REVIEW COMMENTS

FILE # 213-94

TITLE HEADING: Planned Development
Review - Quiznos Subs

LOCATION: 1133 Patterson Road

S/F STACKED PAN-CHANNEL LETTER DISPLAY

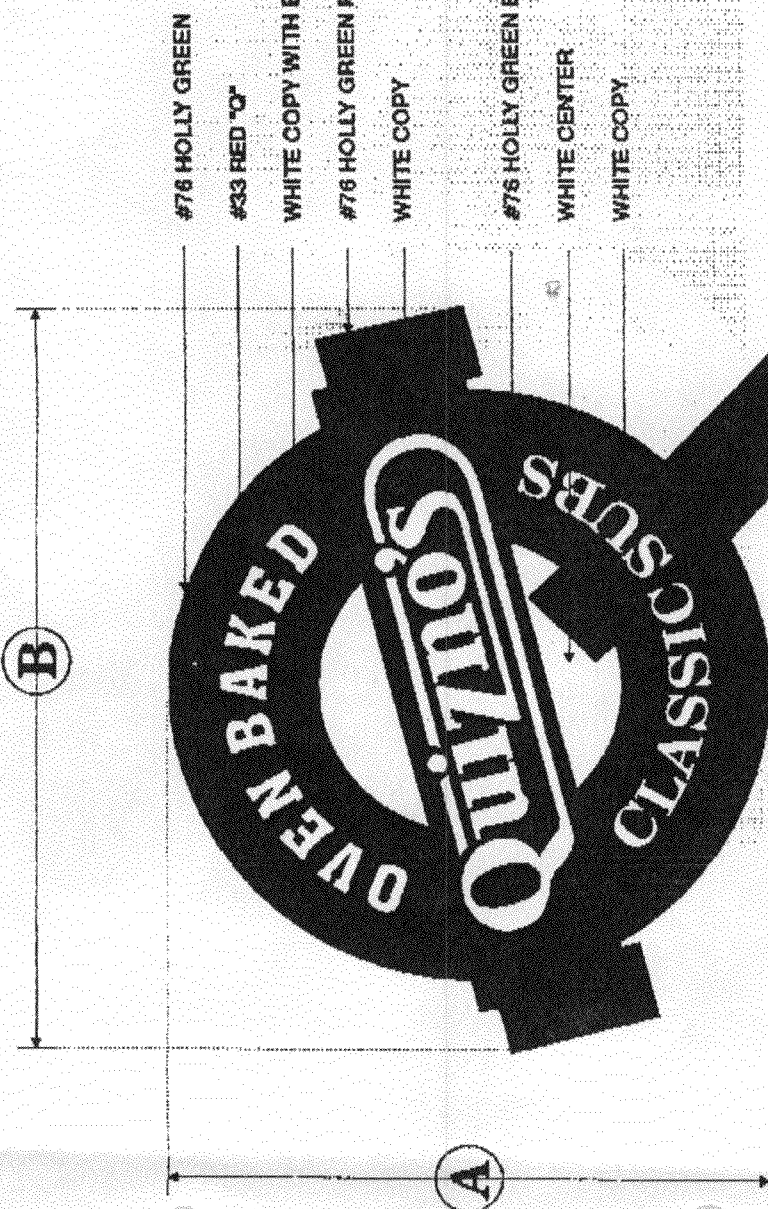
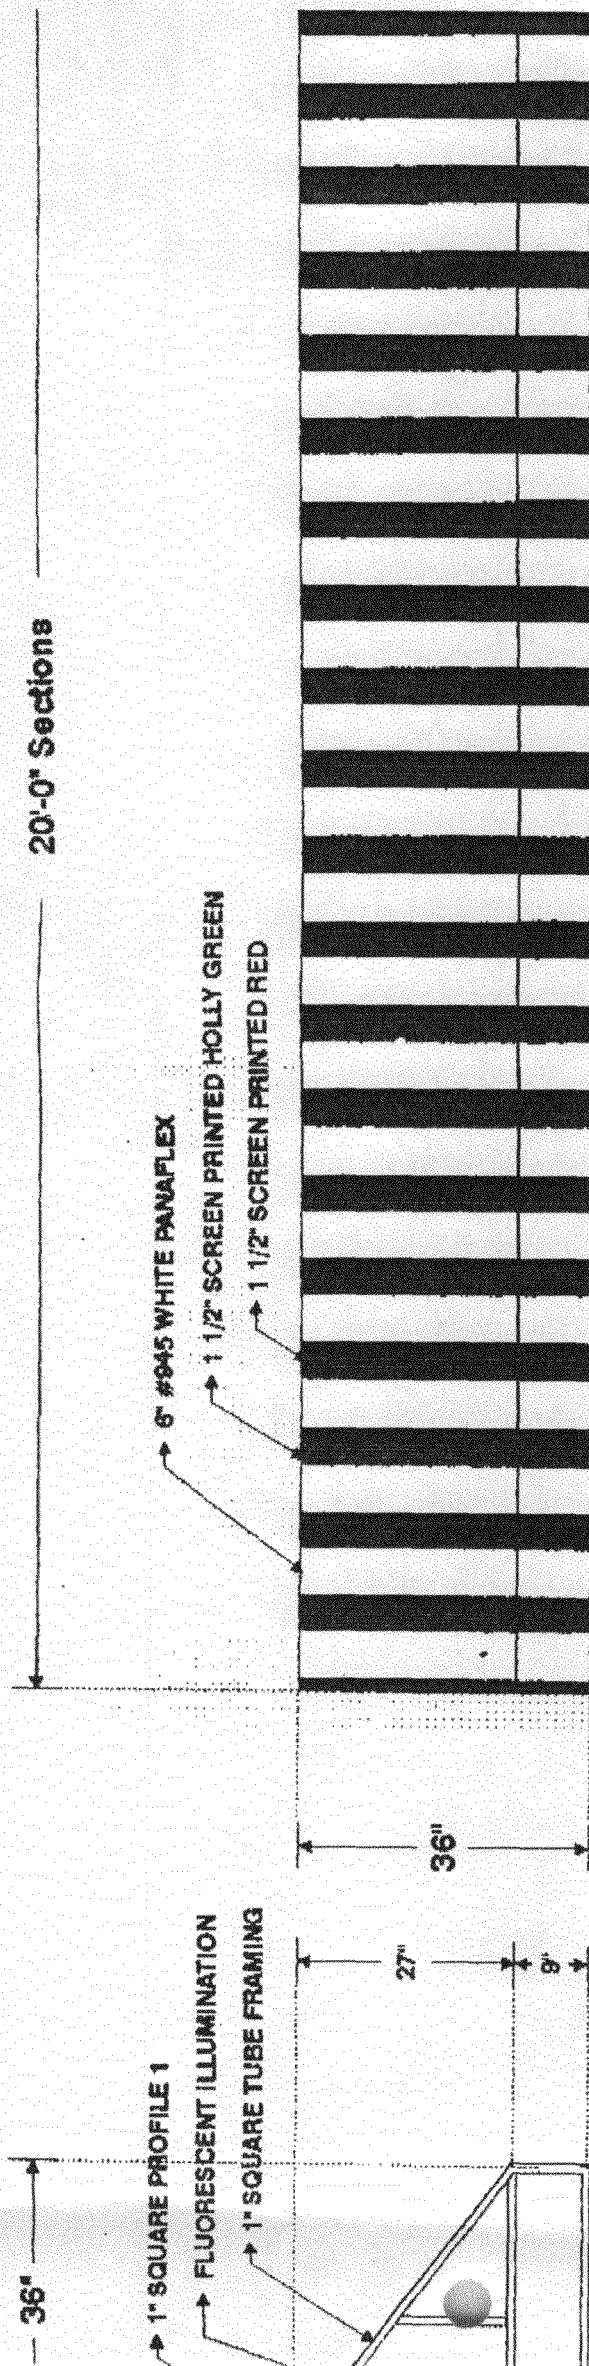
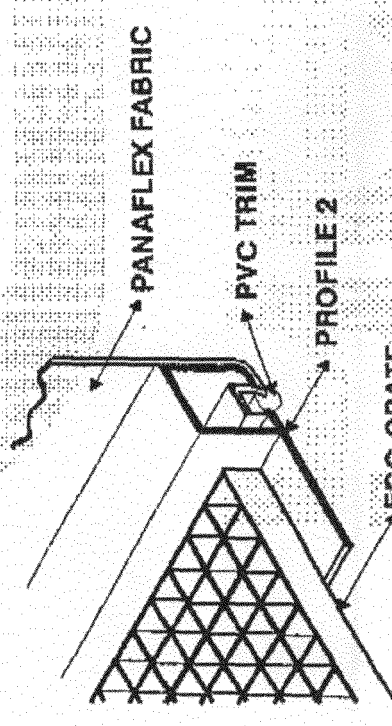
5. SIGNS. Signage is approved as part of a planned development. Need detail of proposed freestanding sign.

Will there be signs on any other facades? If so, need details also.

Signage. Signage for a site is considered part of the approval for the Amended Final Plan. The sign allowance for this parcel is 126 square feet which may be distributed across the site however the developer proposes. In this case, the developer is proposing a total of approximately 150 square feet with one freestanding monument sign and three wall signs. Therefore, the sign plan must be revised to keep the signage within the total allowance for the site. The developer has stated that approval by the Architectural Control Committee is required in order to install the freestanding sign.

QUIZNO'S SITE PLAN

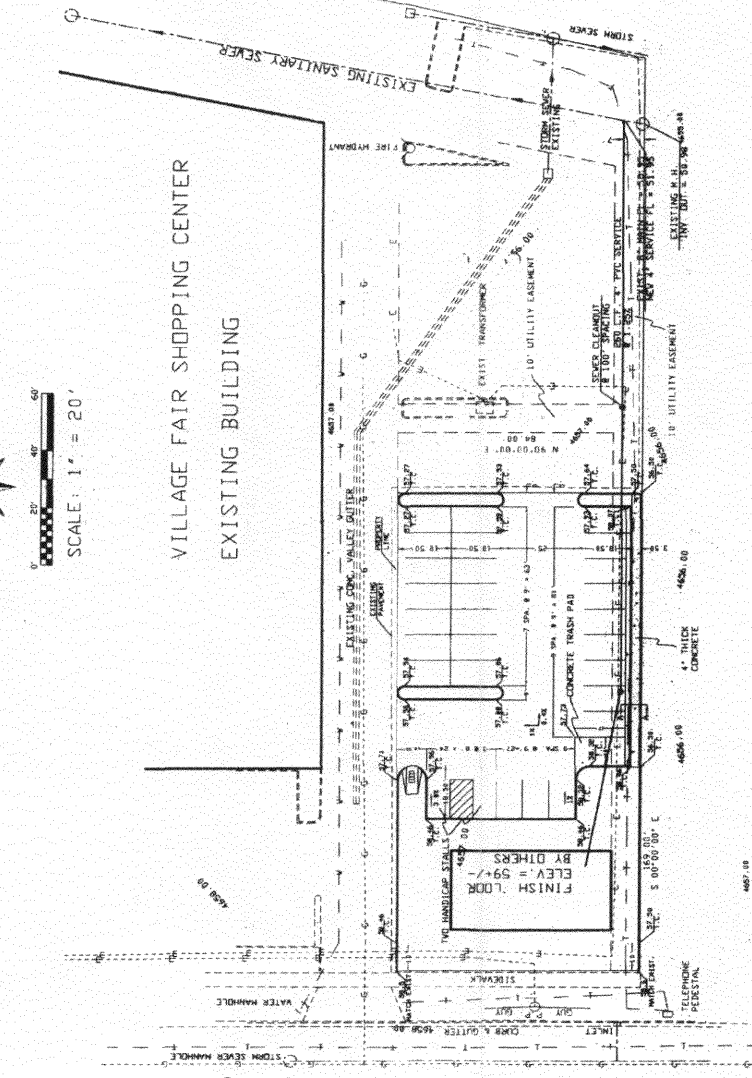
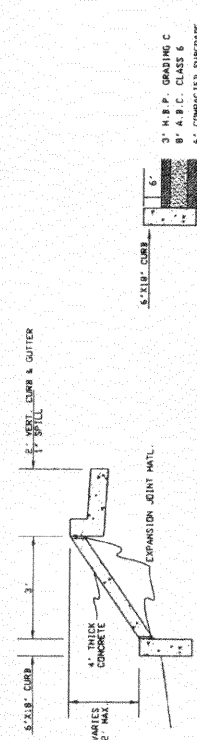
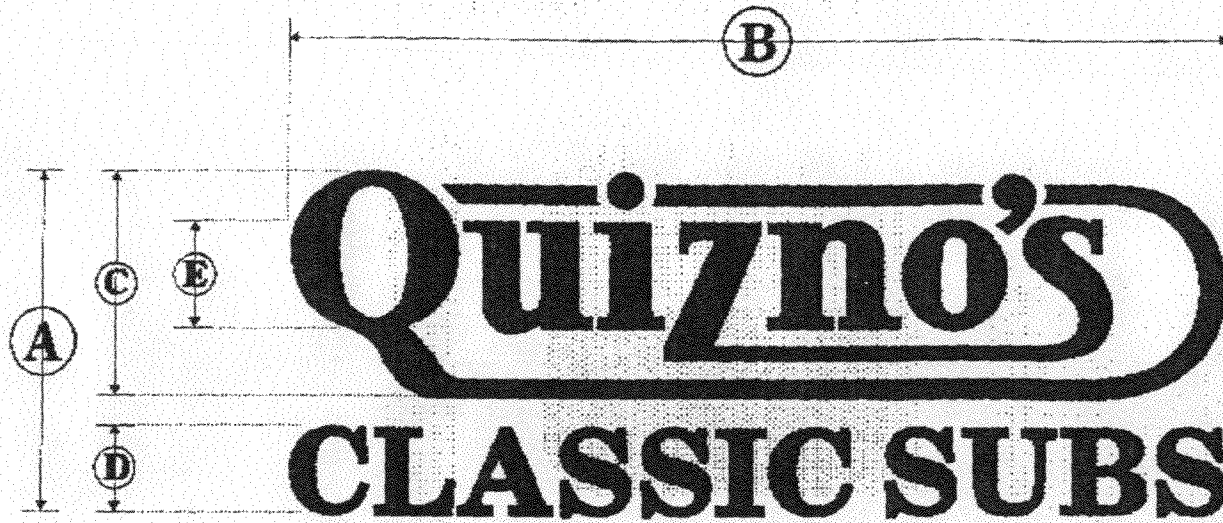
An additional handicap space is required.

City ordinance prohibits increased runoff to adjacent property. The western boundary of the property should be protected, perhaps by curbing along west property boundary. Show parking lot grading.

Show trash container location.

Curbing is required along the western property line.

Parking stall dimensions given do not meet standards (see attached). Revise plan to reflect these standards. If 28 spaces are still provided, 2 handicapped stalls are required.

The existing parking lot light will be sufficient to light the southern end of the new parking area. Suggest providing another light or lights on the building to provide light in the northern part of the parking lot.

The parking requirement for the proposed restaurant is 28 spaces as shown on the plan, including 2 accessible spaces. Appropriate curbing and lighting have also been provided on the revised site plan. The Transportation Capacity Payment (TCP) has been calculated at \$2,383.15 which shall be paid prior to issuing a Planning Clearance.

Drainage. The developer is proposing to drain the site to the south to an existing storm drain inlet that feeds into a line that runs west and eventually into the Buthorn Drain. Due to the impact of this new run-off on the existing system, payment of a drainage fee in the amount of \$6,083.75 will also be required prior to issuing a Planning Clearance. The developer must also provide a more detailed grading plan for the new parking area to ensure proper drainage of the site.
